Enclosure 3 to E-54257

RAI Responses

Safety Analysis Report (SAR), Chapter 2, "Site Characteristics"**RAI NP-2.2-1:**

Figure 2-3
Proposed WCS CISF 1-mile Radius

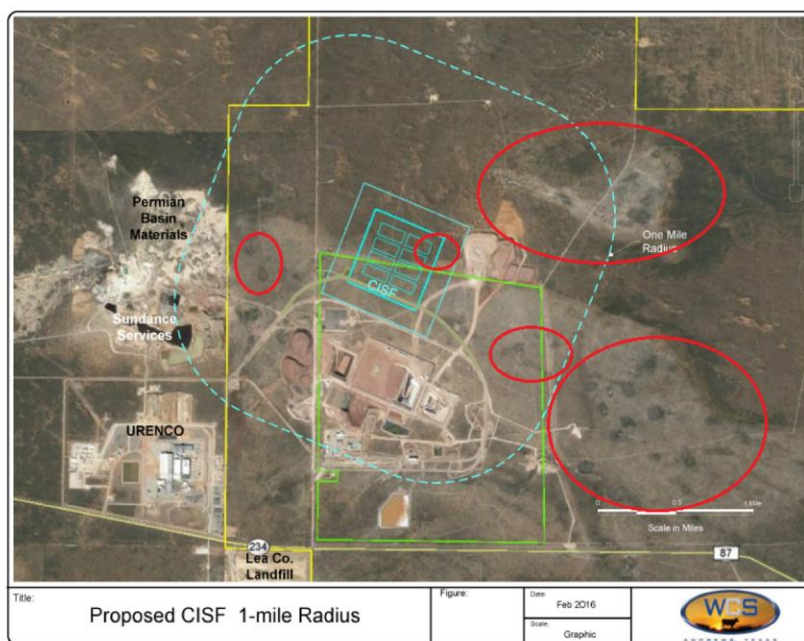
Clarify the origin of the circular features as identified in the red circles on Figure 2-3 below. Specifically, provide the dimensions of the features and determine whether they might represent surface deformation at the site due to subsurface dissolution resulting from past or ongoing natural processes or human activities in the site area, as mentioned in WCS CISF SAR Section 2.6.1. Also, discuss the potential for similar features to develop at the site in the future.

WCS CISF SAR Section 2.6.1 states, “near-surface regional structural controls may be locally modified by differential subsidence related to groundwater dissolution of Permian salt deposits.” However, the SAR does not specify where these locally modified areas of differential subsidence are located relative to the proposed site. The NRC staff noted the history of oil and gas exploration and extraction activities in the site area and the presence of some features in SAR Figure 2-3 that are circular in shape (i.e., similar to sinkholes or swales), some of which are shallow depressions 2 to 7 feet in depth.

Response will be provided in a separate submittal in the near future.

**Figure RAI NP-15-8-1
Clearance Study**

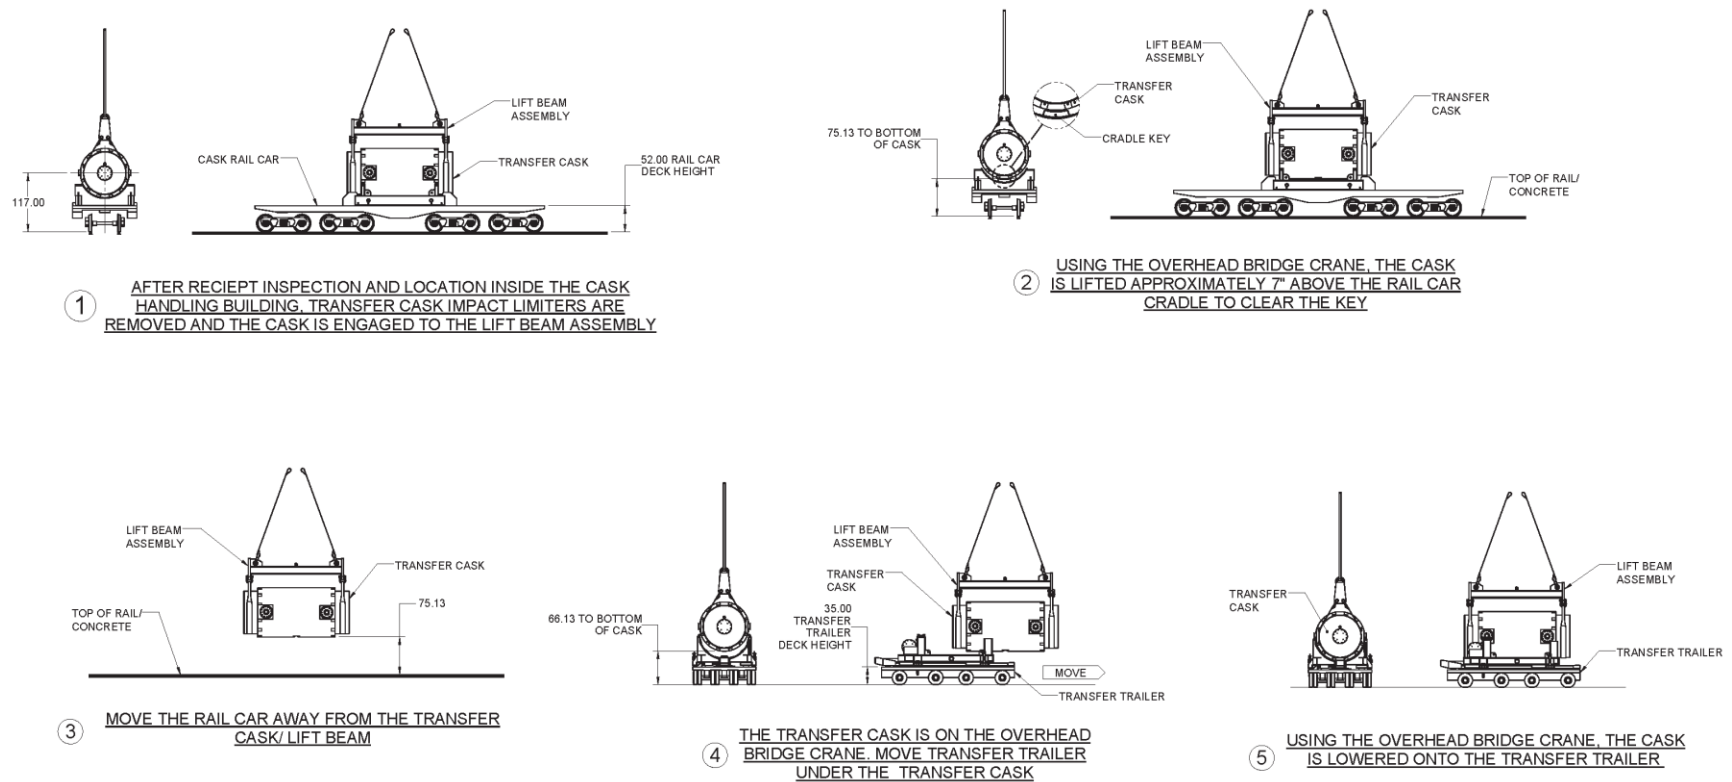
Provide additional information to justify the classification of the 130-ton Crane and the WCS Lift Beam as NITS Components based on the NUHOMS system transfers being limited to heights of less than 80 inches.

The transfer operation (shown in WCS CISF SAR Figure A.5-1) of the loaded MP187 from an incoming railcar to the NUHOMS Transfer Trailer that takes place in the canister handling building (shown in WCS CISF SAR Figure 1-7) appears to involve a lift of the NUHOMS system that is greater than 80 inches because the underside of the MP187 transfer cask (in the horizontal position as shown in Figure A.5-1) will be lifted above the trunnion attachment points on the MP187 Transfer Trailer. As described, the dimensions of the MP187 Transfer Trailer and the MP187 Cask, and the description of the WCS canister handling building and the transfer operation do not support a lift height of no more than 80 inches.

To verify that the NUHOMS® MP187 and MP197 transfer casks can be moved from the railcar to the transfer trailer and skid without lifting the casks above 80 inches above the floor of the Cask Handling Building (CHB), ISP performed a clearance study. ISP reviewed the drawings for several Kasgro Rail Corporation railcars that are suitable for use in transporting these casks. Of the suitable railcars that could be used to transport the casks and contents, ISP chose the highest railcar deck as the basis of its study, which is 52 inches above the floor of the CHB. The transfer trailer that will be used at the WCS CISF has an adjustable deck height. During the transfer of the cask from the railcar to the transfer trailer the deck height is set at 35 inches above the CHB floor.

Figure RAI NP-15-8-1 is a summary of the clearance study performed using solidworks models of the skids, cask and trailer deck heights showing the distance between the bottom of the horizontal cask and the CHB floor at the lift heights required to clear the skids and allow free movement of the cask from the transportation skid attached to the railcar to the transfer skid attached to the transfer trailer. As shown in Figure RAI NP-15-8-1, the cask must be lifted 7 inches above its resting position on the transportation skid to allow it to clear the key way and the balance of the skid. This results in the cask being lifted to less than 76 inches from the floor of the CHB. To load the cask onto the transfer trailer, it can be lowered to just over 66 inches and then slid onto the transfer skid and then set down on the trunnion towers as shown in Figure RAI NP-15-8-1.
